TENNESSEE VALLEY AUTHORITY

Docket Nos. 50-390
50-391

RESPONSES TO REQUESTS FOR ADDITIONAL INFORMATION
IN E. G. ADENSAM'S LETTER TO H. G. PARRIS
DATED JULY 9, 1985
REGARDING TVA'S
UTILIZATION OF THE BLACK AND VEATCH (B&V)
INDEPENDENT DESIGN VERIFICATION PROGRAM (IDVP)
AT WATTS BAR

480V REACTOR MOV BOARD 1:1-A

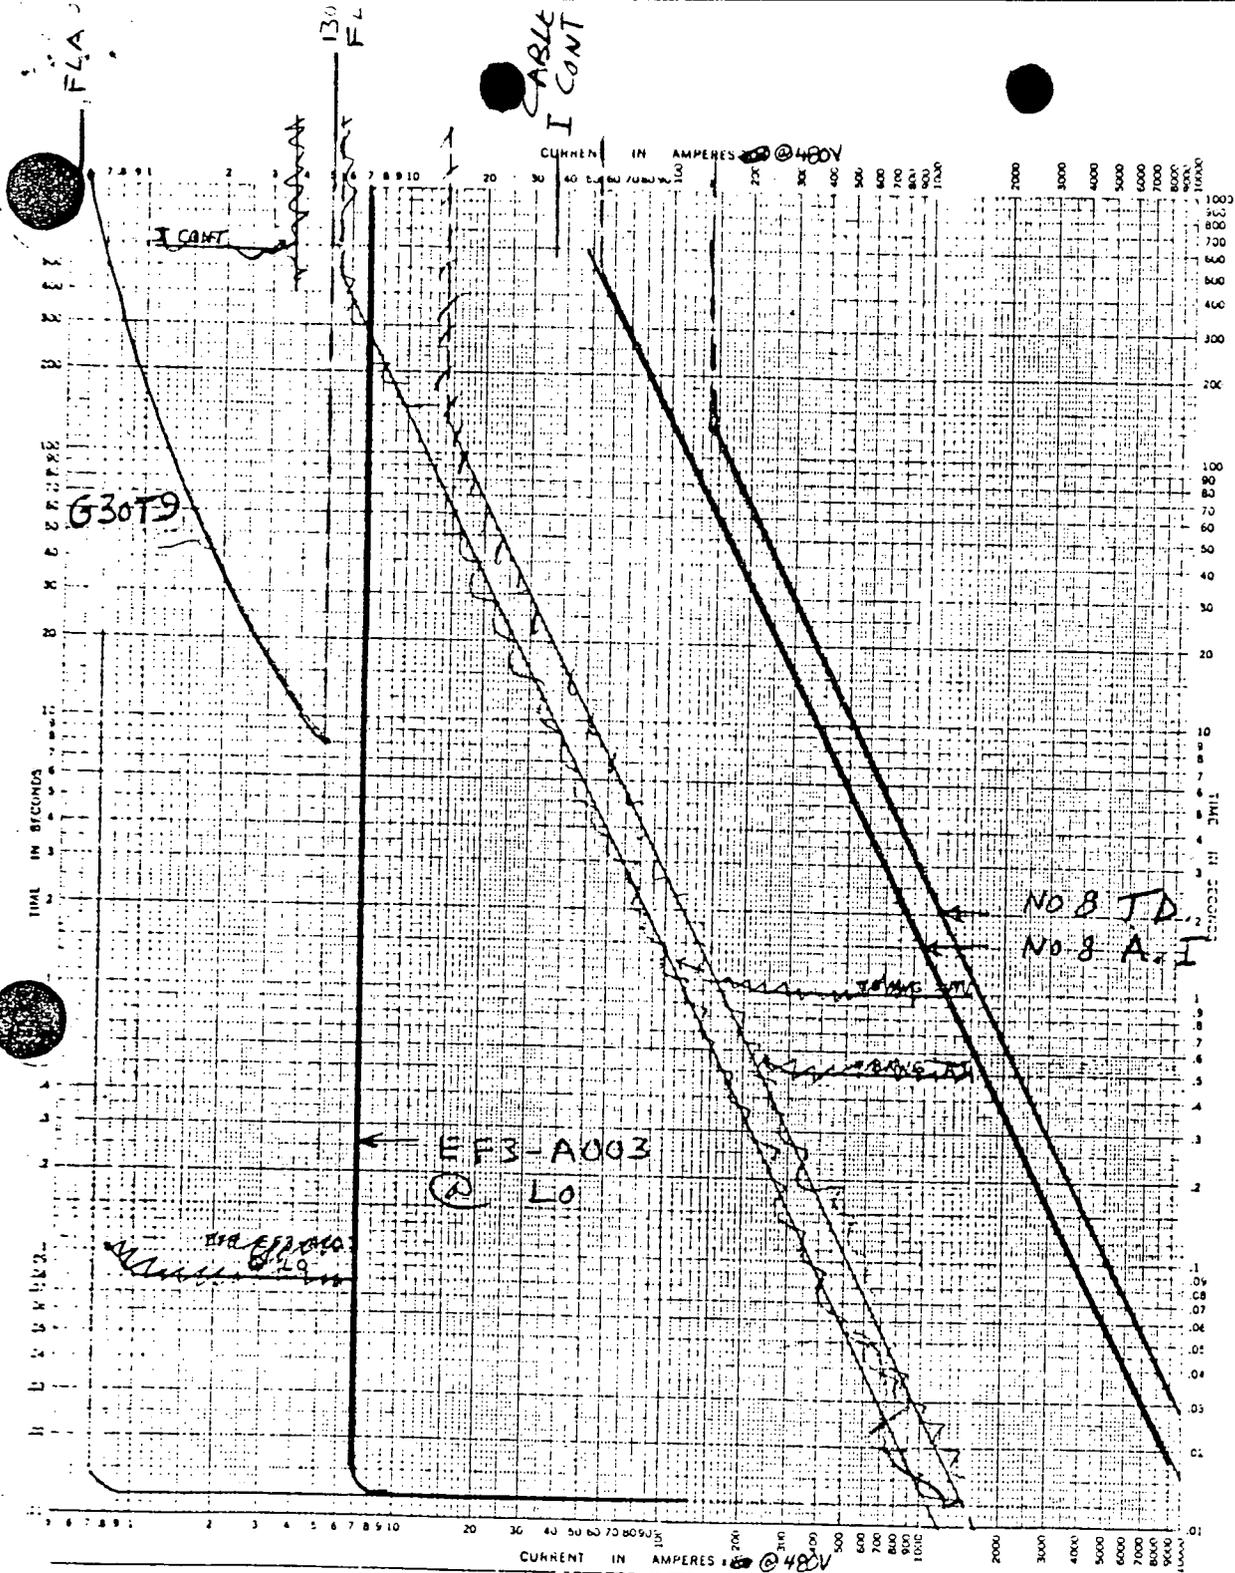
SHEET	COMPT	CURV	PASS/FAIL	REMARKS
B178	2A	75	P1	
B179	2B	M11	P2	
B180	2C	M9	FAIL	^{P2} change OL to T44
B181	10A	77	P1	
B182	2F1	15	P1	
B183	3A	75	P1	
B184	3E	M2	P1	
B185	3D	M11	P1	
B186	4A	75	P1	
B187	4E	42	P1	
B188	5A	M1	P1	
B189	10D	M21	P1	
B190	5E	42	P1	
B191	5F	10	P1	
B192	6D	M21	P1	
B193	6F	42	P1	
B194	7A	41	P1	
B195	7E	41	P1	
B196	7D	M11	P1	
B197	7F	10	P1	
B198	8A	10	P1	
B199	8E	41	P1	
B200	8F	10	P1	
B201	9A	41	P1	
B202	9B	41	P1	
B203	9F	15	P1	
B204	10B	10	P1	
B205	10F	42	P1	
B206	11A	41	P1	
B207	11B	15	P1	
B208	11D	41	P1	
B209	11E	15	P1	
B210	12A	41	P1	
B211	12E	10	P1	
B212	12D	M1	P1	
B213	12E	41	P1	
B214	13A	41	P1	
B215	13E	15	P1	
B216	13E	15	P1	
B217	14A	15	P1	
B218	14E	M3	FAIL	specify T45 OL to pass
B219	14D	42	P1	
B220	14E	41	P1	
B221	16D	42	P1	
B222	16E	M2	P1	
B223	17B	10	P1	
B224	17C	10	P1	
B225	18A	M2	FAIL	^{P2} specify T51 OL to pass
B226	18E	10	P1
